# Work Order ID 99041

Item Name: Replacement Skidtube

DRAWING NO. D2580	TITLE 205 SKIDTUBE ASSEMBLY	REV. E	DART AEROSPACE LTD ENGINEERING ORDER		D.E.O. NO. D2580-E-1	SHEET NO. SHEET 1 OF 1	SCALE NTS	
DRAWN <i>UP</i>	CHECKED <i>ASS</i>	MFG. APPR. <i>ER</i>	APPROVED <i>[Signature]</i>	DE APPR. <i>[Signature]</i>				
DATE 11.12.13	DATE 11.12.13	DATE 11.12.13	DATE 11.12.13	DATE 11.12.13

SECTION B-B D5-2  
SCALE 5X

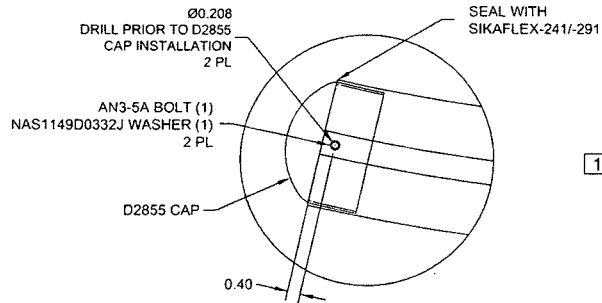
SECTION B-B, SECTION F-F, & SECTION I-I ARE AMENDED AS FOLLOWS  
FOR ALL HOLES THAT WERE ORIGINALLY C'BORED:

CHANGE ALL C'BORED WELDED CROSSBOLT SPACERS TO SWAGED SPACERS

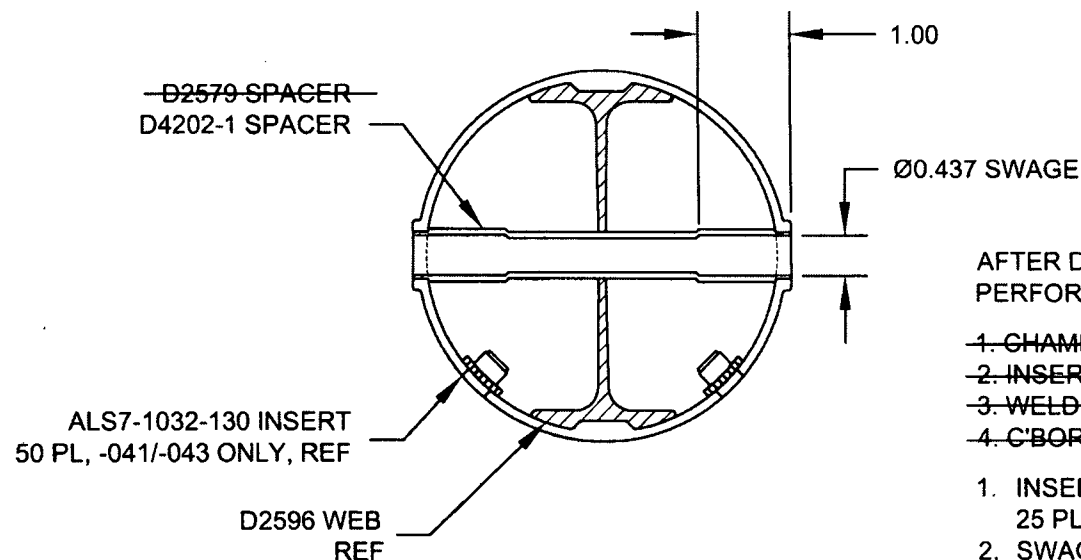
QTY	QTY	QTY	PART NUMBER	DESCRIPTION
-041	-045	-047		
20	24	25	D2579	CROSS BOLT SPACER

4		* D2579	CROSS BOLT SPACER
20	20	25	D4202-1	SPACER

WELD 4X D2579 SPACERS PER DWG  
IN LOCATIONS MARKED "NO C'BORE".  
REF SHEET 4 OF DWG.
